# ANN ARBOR HISTORIC DISTRICT COMMISSION

# Staff Report

ADDRESS: 317 Koch Avenue, Application Number HDC14-010

**APPLICATION:** The applicant seeks HDC approval to replace the west basement wall, install two egress windows with wells; and construct a two-story rear addition, with a two-car garage on the first story and a bedroom on the second; and extend the existing gravel driveway.

Proposed East Elevation

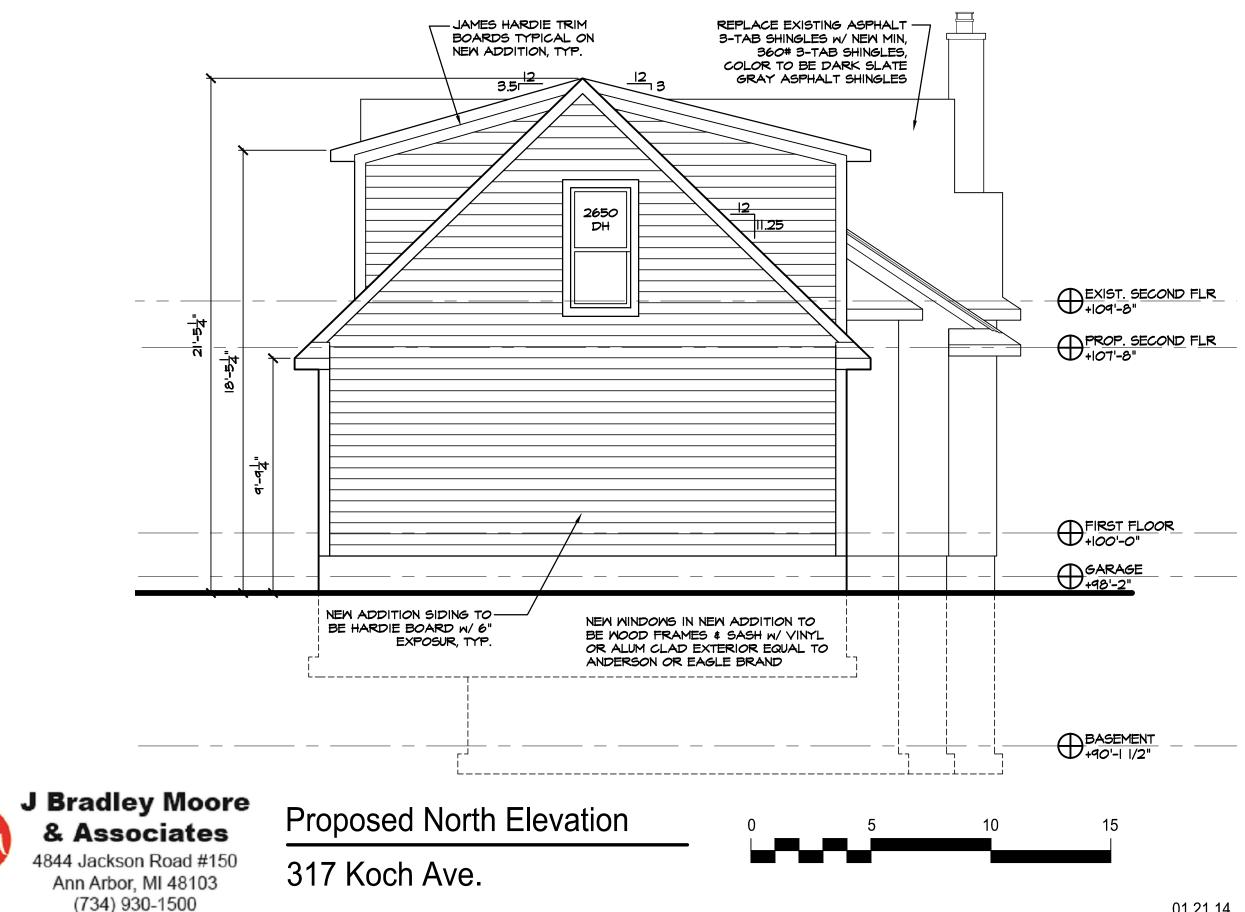
- 2. The taller rear portion of the proposed addition is eleven inches higher than the ridge of the existing house. Because of the separation from the existing house by the one-story section, staff believes the rear section's taller ridge will not detract from the original house or call attention to itself. The applicant has constructed the lower-level garage to be as low as possible and still meet building code.

- 3. The two-car garage would be accessed via a shared gravel driveway along the east property line (between 315 and 317 Koch). This driveway was originally installed as a two-track on 317's property, and currently ends near the back of the houses.

**Proposed West Elevation**

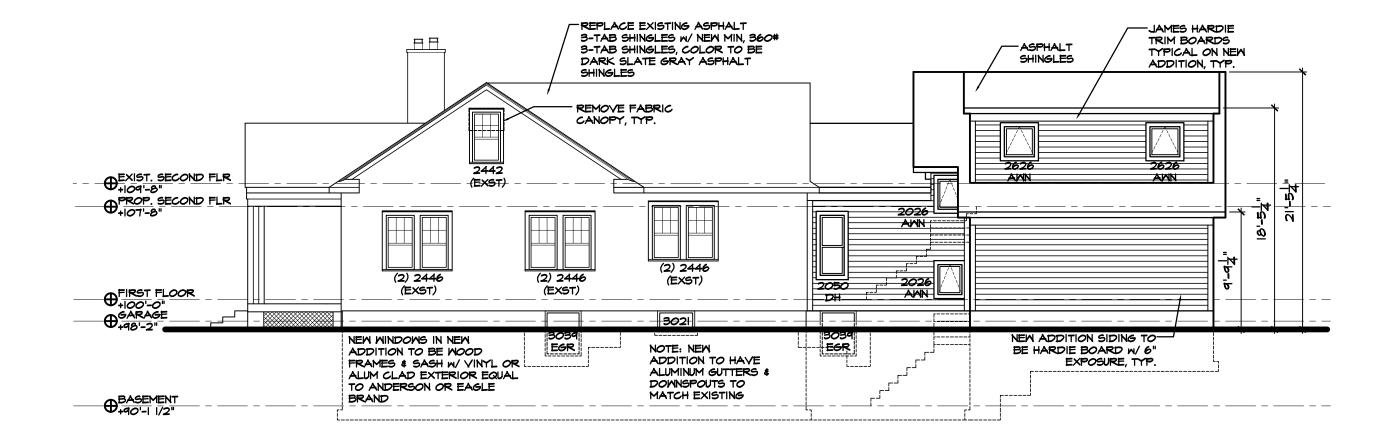
- 4. An area well with a new egress window is proposed on the new west basement wall. The window would be 30" by 34" with a poured concrete well.
- 5. Staff believes that the proposed work meets the Secretary of the Interior's Standards, the Secretary of the Interior's Guidelines for Rehabilitation, and the Ann Arbor Historic District Design Guidelines.
